DIST. 54 REGION \_\_\_\_\_W.P. No. 774-93-00

**Geotechnical Foundation Report  
Embankment Section  
Trout Creek ByPass  
Glen Roberts Road Connection  
Stations 9+740 to 9+960  
GWP No. 774-93-00  
District 54, Sudbury**

SO7524G/L/F  
March, 1999

Figure 4

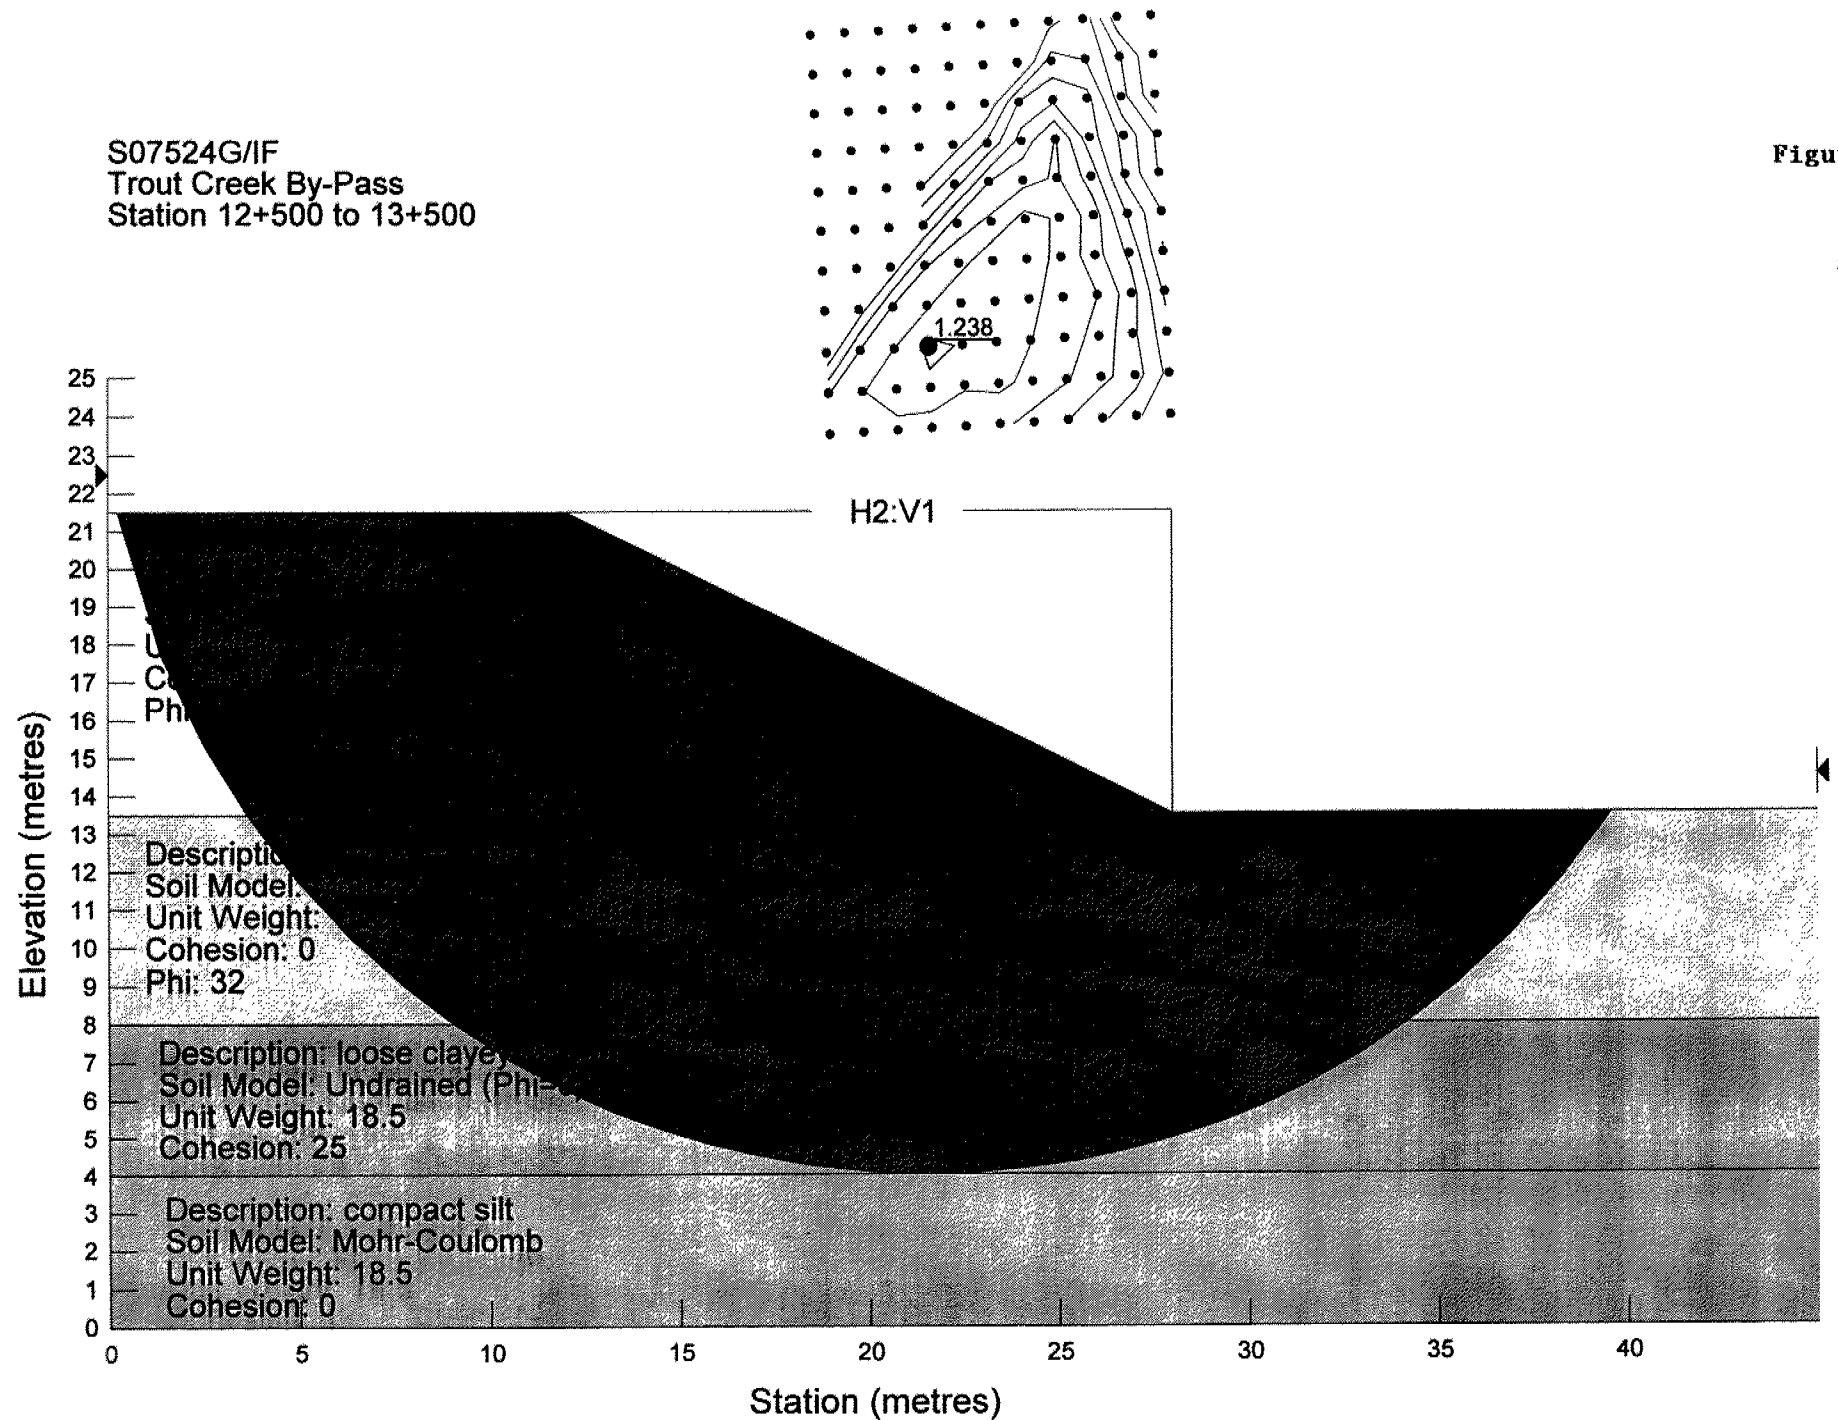
On Figure 4, the slope geometry should be clarified as 1.25H:1V rather 2.5H:1V.
